RE: M-1977-439 Technical Revision (TR-06) responses to Adequacy Review No. 1

Please find below our responses to your Adequacy Review No. 1 dated June 28, 2023.

MARTIN MARIETTA  
HOME OFFICE  
LARIMER COUNTY, COLORADO  
RECLAMATION PLAN

M-1977-439 Home Office Well Monitoring

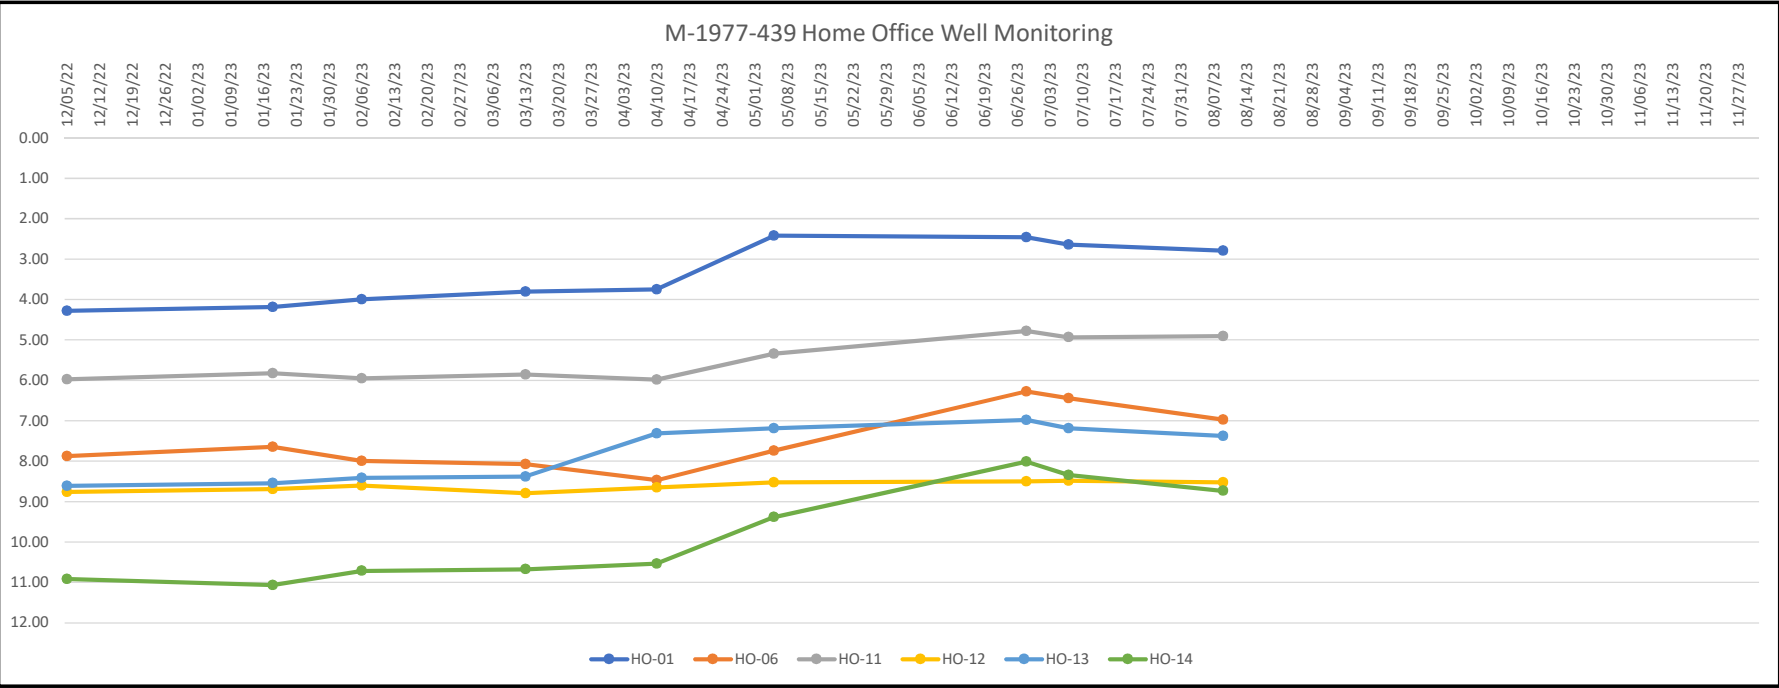
1. In Adequacy Review Response No. 3 of AM-04, dated February 7, 2023, the Operator committed to monthly groundwater level monitoring and submitting those results on a quarterly basis. To date, the Division has not received any groundwater level monitoring data. Please submit all missing groundwater level monitoring data. At a minimum, the submittal shall include the well location map, table(s) that clearly define ground surface elevation for each well location, depth to groundwater from ground surface, graphs of groundwater levels over time, and a statement as to whether the groundwater level has been within 4-feet of ground surface and if so, for how long.

*Per AM-04 approved on February 15, 2023, we are to submit the water level data quarterly. Please find the data enclosed in the format that was requested.*

*As part of AM-04, we did agree to install an underdrain on the north side of G-I if the groundwater levels were within 4-feet of the ground surface for 2 consecutive months. Our monitoring data for HO-01 was hovering around 4 feet until we used the unlined ditch just north of the well to fill the reservoir in May and then unfortunately we have gotten record rain fall every month since. As you can see on the data pulled from the Colorado State University Colorado Climate Center Data for Fort Collins, the past few months have seen between 400% and nearly 1000% more rain than the past 5-year average. Our data for this well shows the water depth has been within 4 feet of the surface for HO-01 since February. There will be more discussion on this shortly in our response to CT-01.*

F1

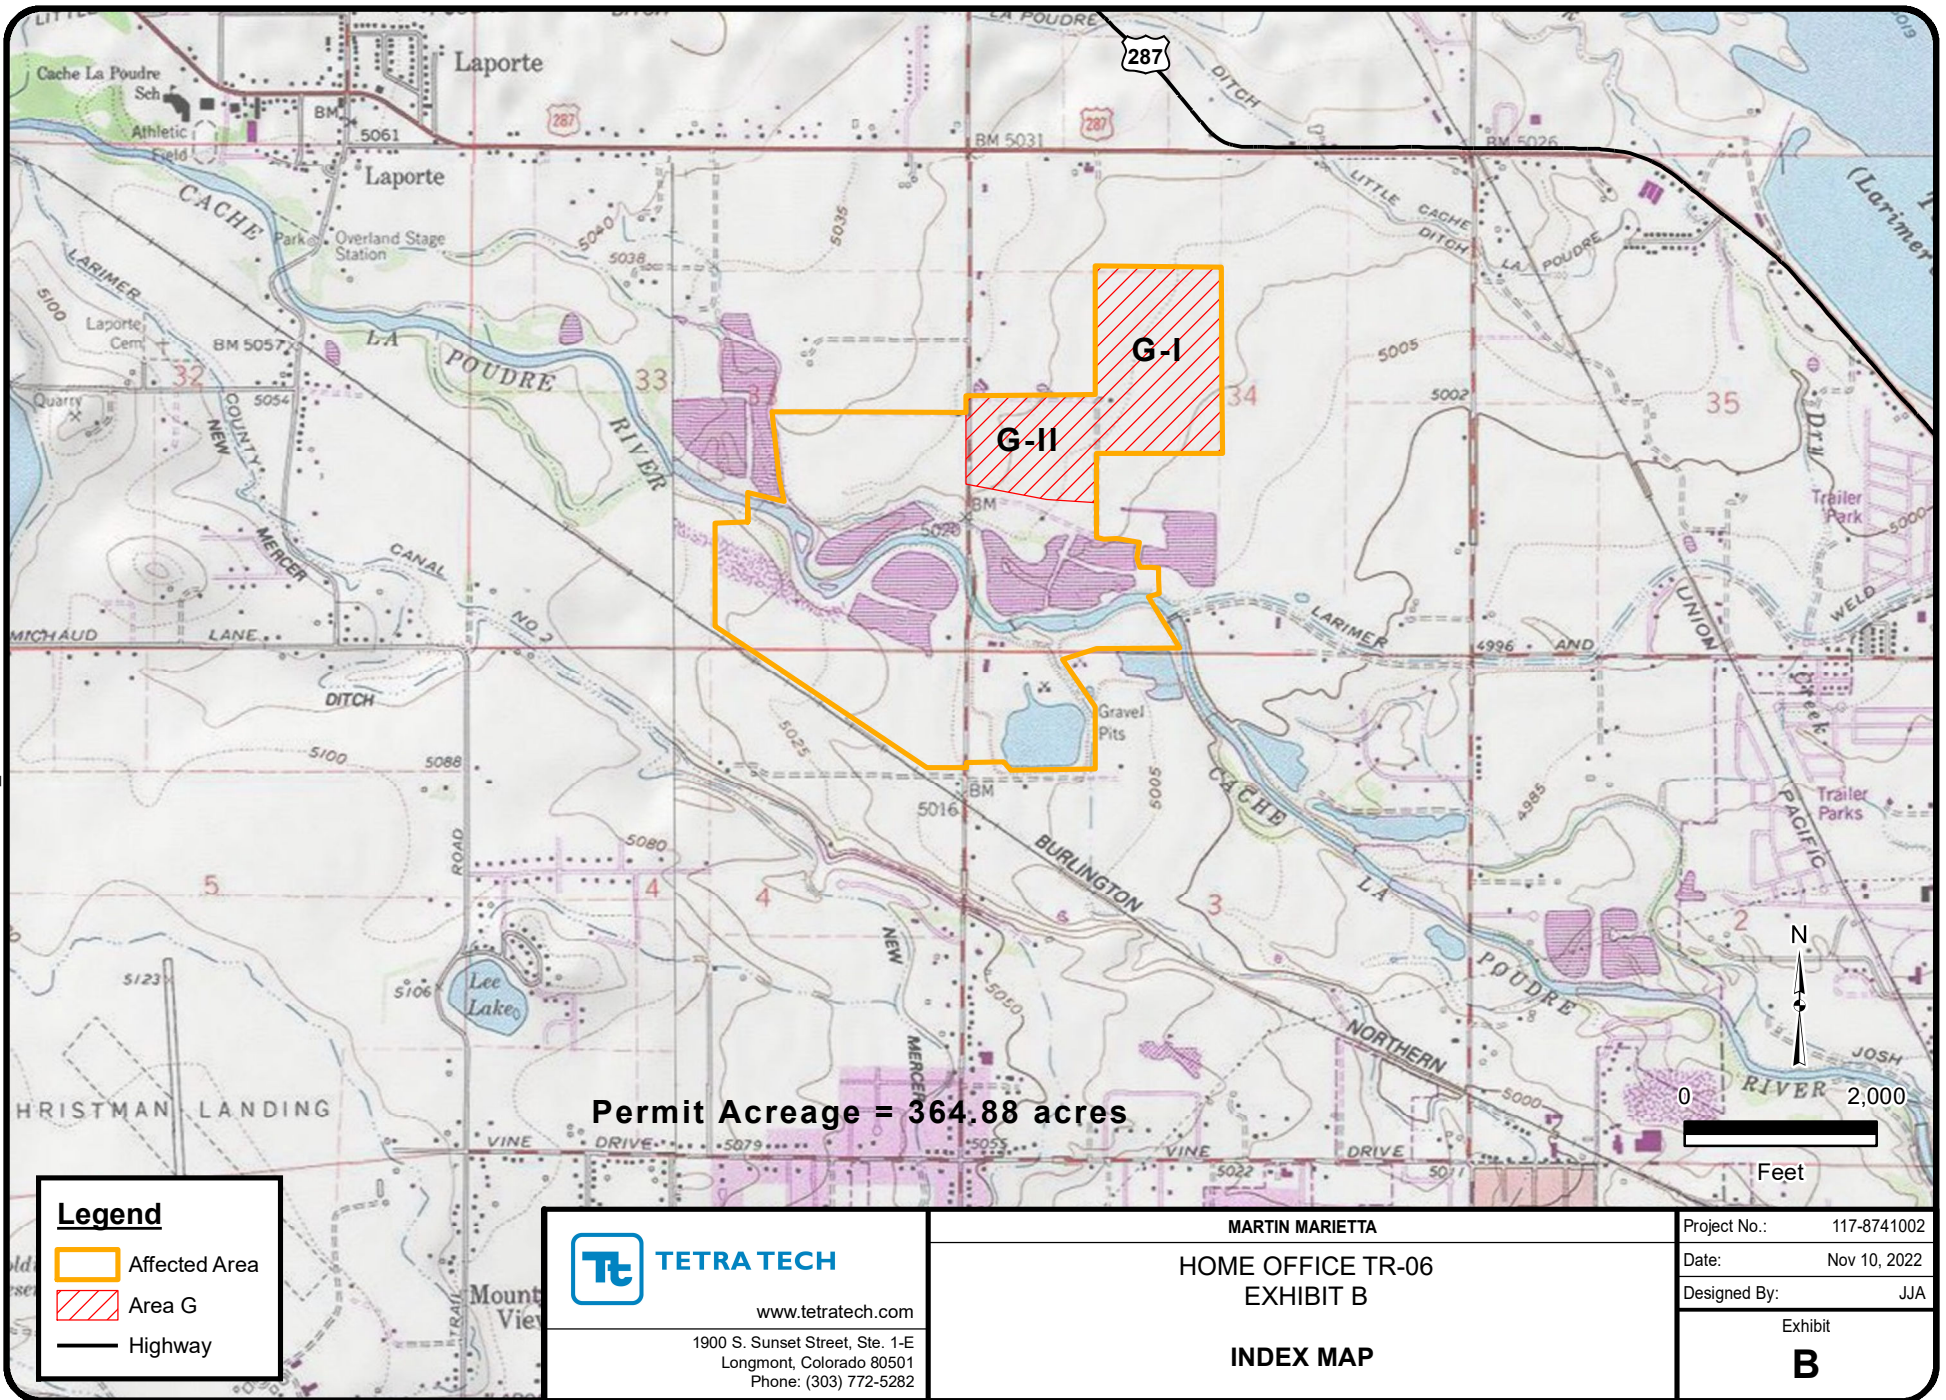
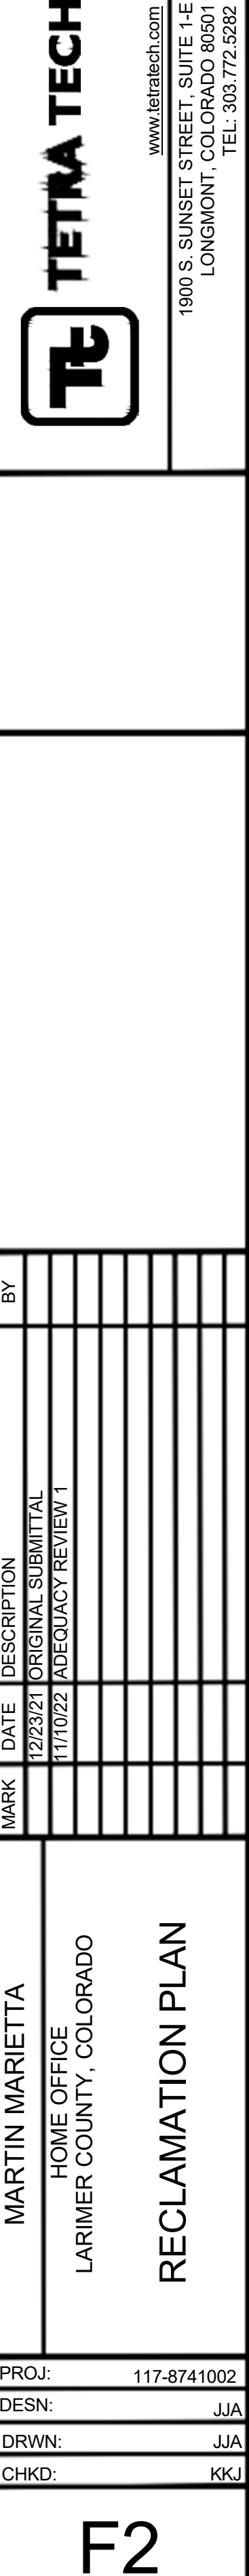
4. Please clearly show on the maps the different underdrains, West and North and any others using different shading so it is clear what specific segment of underdrain is part of TR-6.

*Revised Exhibit F is enclosed.*

WEST UNDERDRAIN (INSTALLED)  
NORTH UNDERDRAIN (INSTALLED)  
NORTH EXTENSION TO THE EAST (NORTH OF G-I AS PROPOSED W/TR-06)
